City of Capitola Planning Commission Meeting Agenda Thursday, November 06, 2025 – 6:00 PM

B. 506 A Pine Street

Project Description: Application #24-0138. APN: 036-022-10. Design Permit for a second-story addition to an existing duplex and new detached, two-story residential unit on a 0.28-acre site located at 506 Pine Street, within the Residential Multifamily-Medium (RM-M) zone district. This project is not located within the Coastal Zone.

Project Design Review

Detached Unit South Elevation

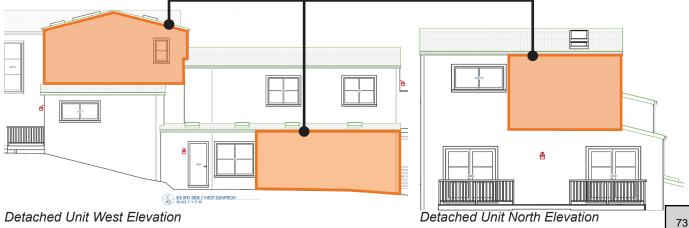
Incorporate a minimum of two facade design strategies per OS 17.82.080.B.3 in a manner consistent with the selected style. Potential solutions include introduction of an additional material on the ground floor similar to the wood paneling on the existing duplex, providing a porch, and/or any additional design intervention that improves the street facing elevation.

Revise the west and north elevations of the detached unit to remove large unarticulated blank wall space per OS 17.82.080.B.1.a. Potential solutions include additional windows, architectural detailing, variation in wall plane, and/or any design intervention that positively impacts the proposed detached unit street facing elevation.

Rendering of Proposed Detached Unit

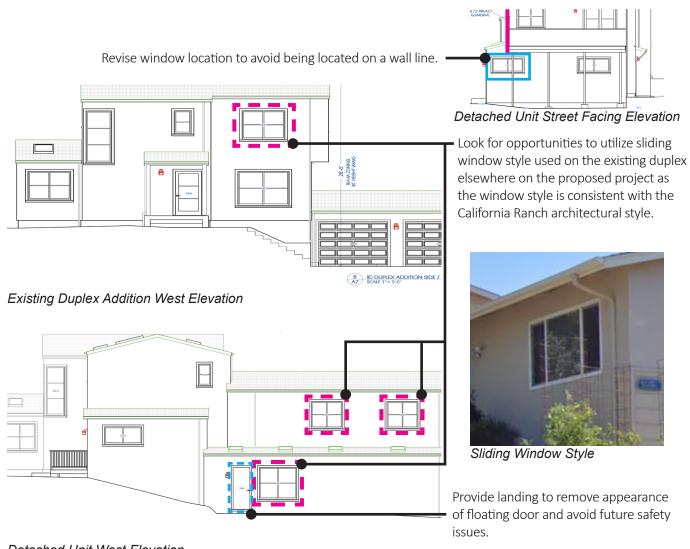
Applicant should match the pitch of the detached unit and duplex addition to the existing duplex. Similarly, utilize the same eave overhang shown on the existing duplex on the proposed detached unit as this design feature is consistent with the selected California Ranch architectural style.

A primary entry contributes to the overall identity of a building by defining the architectural style and engaging with the public realm. While the applicant has minimally emphasized the primary entry of the proposed detached unit, the entry faces inward and is not visible from the public realm. The applicant must revise the floor plan of the detached unit to provide a street facing primary entry and further solidify the connection with the public realm to be in compliance with OS 17.82.060.B.3.b and Figure 17.82-3. The applicant may opt to seek director approval for entry exceptions instead of revising the floor plan per OS 17.82.060.B.3.c, however, this path would require the applicant to satisfy the following requirements: one pedestrian walkway per fifty feet of property street frontage connecting the adjacent sidewalk to the interior of the lot; landscaping between the residences and street; street facing buildings not exceeding a width of 100 feet. The applicant has minimally provided awnings/coverings in an effort to emphasize primary entries on the detached unit and existing duplex addition. However, to further establish and delineate the primary entries for future users, primary entries must include a porch, covered entry, or recessed entry clearly visible from the street (OS 17.82.060.C.1.a).

The applicant must revise the floor plan to relocate the primary entry of the detached unit to be street facing to establish a connection with the public realm (OS 17.82.060.B.3.b).

Detached Unit South Elevation

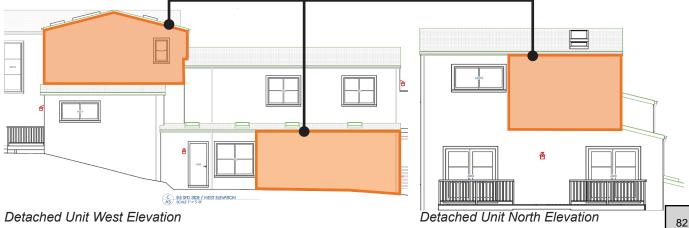
Incorporate a minimum of two facade design strategies per OS 17.82.080.B.3 in a manner consistent with the selected style. Potential solutions include introduction of an additional material on the ground floor similar to the wood paneling on the existing duplex, providing a porch, and/or any additional design intervention that improves the street facing elevation.

Revise the west and north elevations of the detached unit to remove large unarticulated blank wall space per OS 17.82.080.B.1.a. Potential solutions include additional windows, architectural detailing, variation in wall plane, and/or any design intervention that positively impacts the proposed detached unit street facing elevation.

Rendering of Proposed Detached Unit

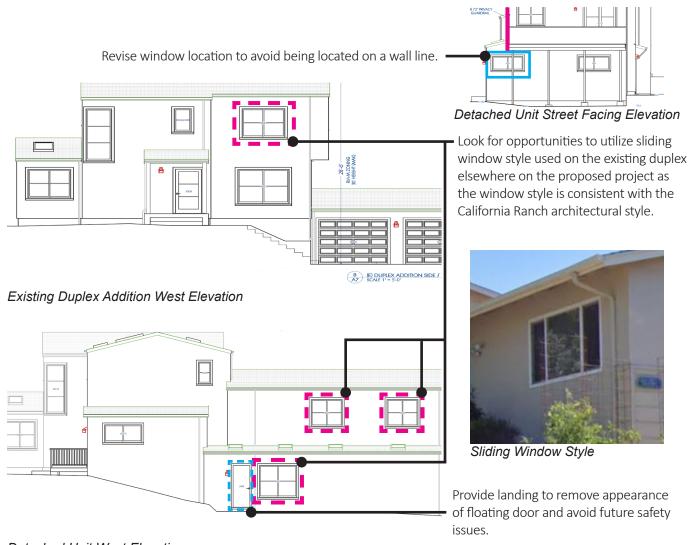
Applicant should match the pitch of the detached unit and duplex addition to the existing duplex. Similarly, utilize the same eave overhang shown on the existing duplex on the proposed detached unit as this design feature is consistent with the selected California Ranch architectural style.

A primary entry contributes to the overall identity of a building by defining the architectural style and engaging with the public realm. While the applicant has minimally emphasized the primary entry of the proposed detached unit, the entry faces inward and is not visible from the public realm. The applicant must revise the floor plan of the detached unit to provide a street facing primary entry and further solidify the connection with the public realm to be in compliance with OS 17.82.060.B.3.b and Figure 17.82-3. The applicant may opt to seek director approval for entry exceptions instead of revising the floor plan per OS 17.82.060.B.3.c, however, this path would require the applicant to satisfy the following requirements: one pedestrian walkway per fifty feet of property street frontage connecting the adjacent sidewalk to the interior of the lot; landscaping between the residences and street; street facing buildings not exceeding a width of 100 feet. The applicant has minimally provided awnings/coverings in an effort to emphasize primary entries on the detached unit and existing duplex addition. However, to further establish and delineate the primary entries for future users, primary entries must include a porch, covered entry, or recessed entry clearly visible from the street (OS 17.82.060.C.1.a).

Response: Pitches are the same- please see sheet A5 & A7

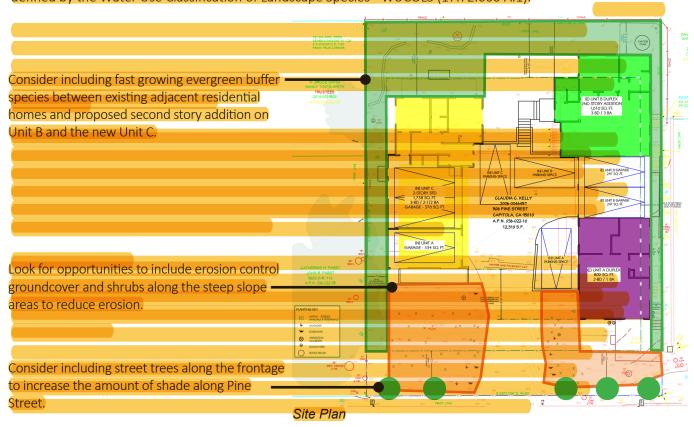
The applicant has provided a Landscape Plan on Sheet A11 with a preliminary plan showing the existing and proposed vegetation. However, the Landscape Plan should provide plant symbols which accurately reflect the width the vegetation will grow and a circle is recommended for trees and shrubs to better reflect the ultimate size the plants will grow (17.72.040 B.6). The tree diameter of existing trees are provided on the Landscape Plan; however, outer limit of tree canopy should be included and a label identifying if the existing trees will remain or be removed (17.72.040 B.5).

In general, the landscape design has an appropriate sense of unity, proportion, and balance with generally harmonious colors and durable plant species The vegetation appears to be primarily drought-tolerant and generally reflects the "California Ranch" character. However, the Planting Key should list the genus and species of all proposed plants (17.72.040 B.6). In particular, the Native – Edibles, Annuals & Perennials must provide a list of the vegetation that is proposed. Additionally, the water use for each plant should be included in the Planting Key to understand the exterior water requirements for the project and to ensure compliance with the water use efficiency ordinance (17.72.030). Ensure a minimum of ninety percent of plants and trees are drought-tolerant (low or very low water use) as defined by the Water Use Classification of Landscape Species - WUCOLS (17.72.060 A.1).

To further enhance the landscape design consider including fast growing evergreen buffer species between existing adjacent residential homes and the proposed the second story addition on Unit B and the new Unit C. Additionally, consider including erosion control groundcover and shrubs along the steep slope areas to reduce erosion. Lastly, consider including street trees along the frontage to increase the amount of shade along Pine Street.
